**SECTION 87F REPORT OF JAMES STUART LAMBIE –
TERRESTRIAL ECOLOGY**

**MANAWATŪ-WHANGANUI REGIONAL COUNCIL AND GREATER
WELLINGTON REGIONAL COUNCIL**

28 April 2023

Figure 1. The location of “O-te-pua” (marked in red) in relation to the Parauaku Swamp remnants affected by the Project (marked with a black arrow). Location data care of GWRC, current as at April 2023.

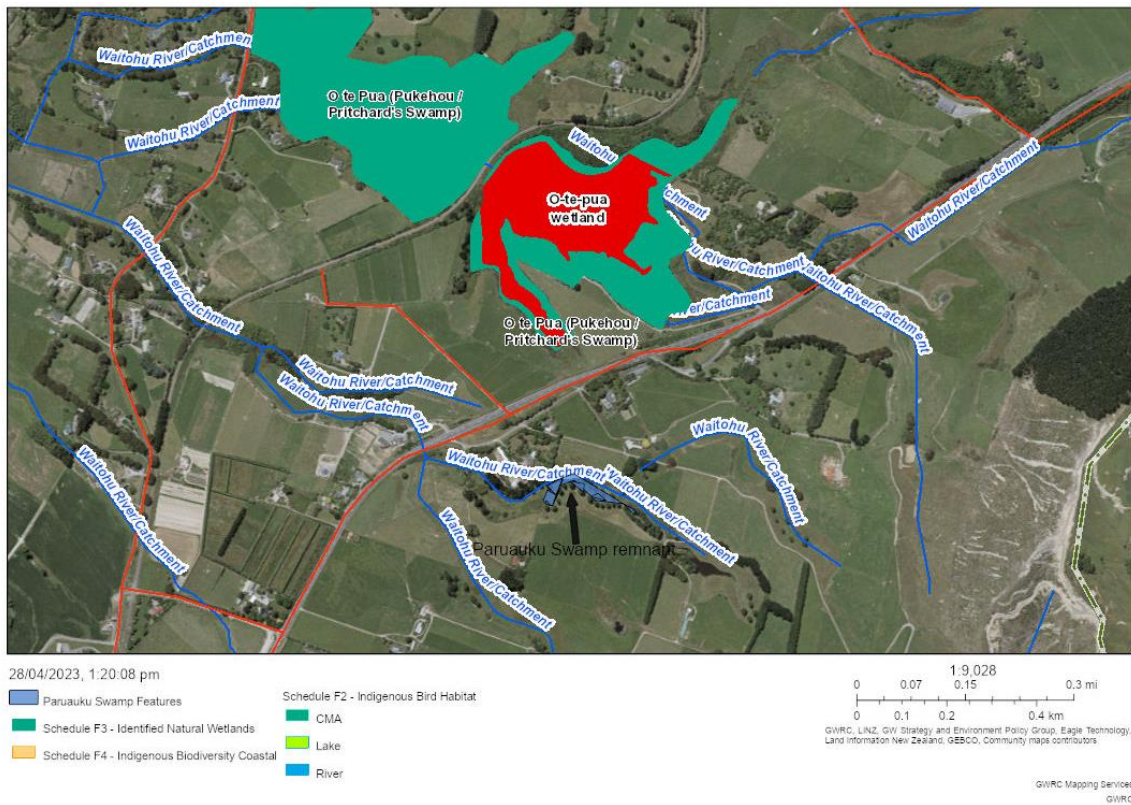
28. “O-te-pua Wetland” (referred to as Paruauku Swamp in Waka Kotahi’s ecological assessment) is affected by the Project, potentially engaging Policy P49. However, on closer review of the GWRC Maps, the Schedule C1 “O-te-pua Wetland” site of significance does not overlap with the Paruauku Swamp remnants affected by the Project (See **Figure 1**, Section M).

Figure 3. The locations of “Koputaroa Rail Wetland” and “Koputaroa Swamp 3 (top centre of image) in relation to the rail corridor, SH57 and Koputaroa Road. Location data care of Horizons, current as at April 2023.

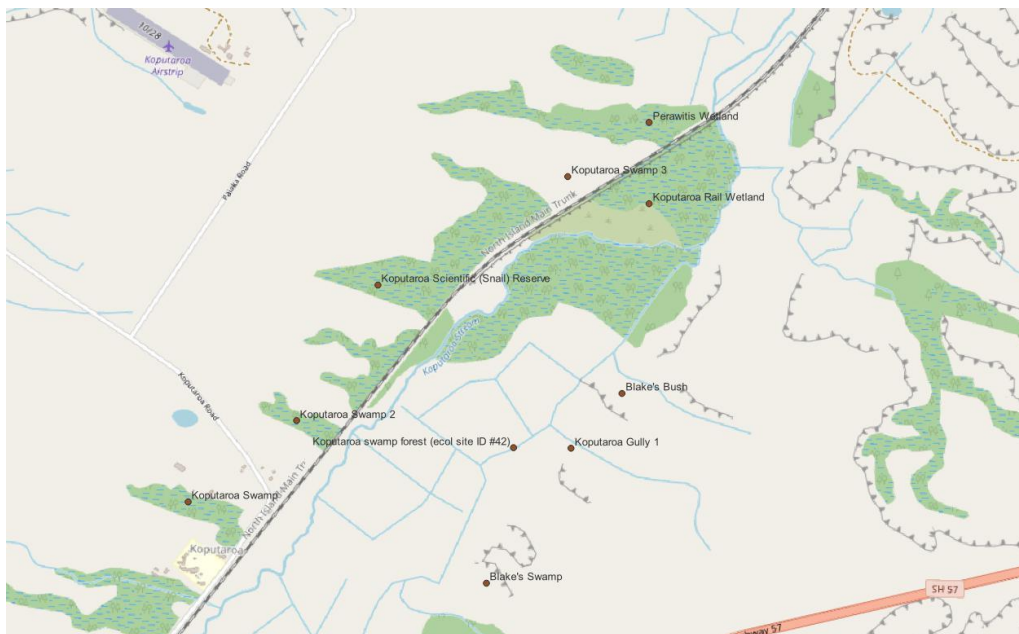
97. “Koputaroa Rail Wetland” is synonymous with Te Ripo o Hinemata and lies to the east of the North Island Main Trunk rail corridor between the rail corridor and the left bank of the Koputaroa Stream (refer to Figure 3; Section M). The wetland is perched above the stream but is subject to inundation from the Koputaroa Stream, as well as having internal perennially flowing springs which give the wetland a swamp character. The site is recorded in Horizons’ wetland inventory and is regarded as being poor both in terms of the hydrological state and wetland vegetation condition.⁴⁸ Mr Goldwater identifies that approximately 9 hectares of the site will be subject to hydrological reinstatement, planting and pest management.⁴⁹

98. “Koputaroa Swamp 3” lies to the west of the rail corridor (refer to Figure 3: Section M). While not synonymous with Te Ripo o Hinemata, the site is also subject to the wetland restoration aspirations of the kaitiaki. After a visit circa 2004 to assess the site’s condition, it was considered by Horizons as ‘lost’ due to the lack of any indigenous signature and the high degree of drainage (it does not appear in the inventory for that reason). I note that the site is possibly wetter today than when assessed in 2004 due to cessation of drain maintenance. The site is subject to runoff from the higher land to the east and there are internal springs that cause the site to be quite boggy in places away from the drains. Presently, the character is more like “marsh” wetland, but this is due to drainage patterns. A “swamp” character could be induced by infilling the drains and letting the water meander through the site. I calculate that there is conceivably 5.7 hectares of land managed by Manawatū Kukutauaki No. 3 Sec 2E Trust that could be readily restored to indigenous-dominated swamp habitat through drainage manipulation and native vegetation planting.
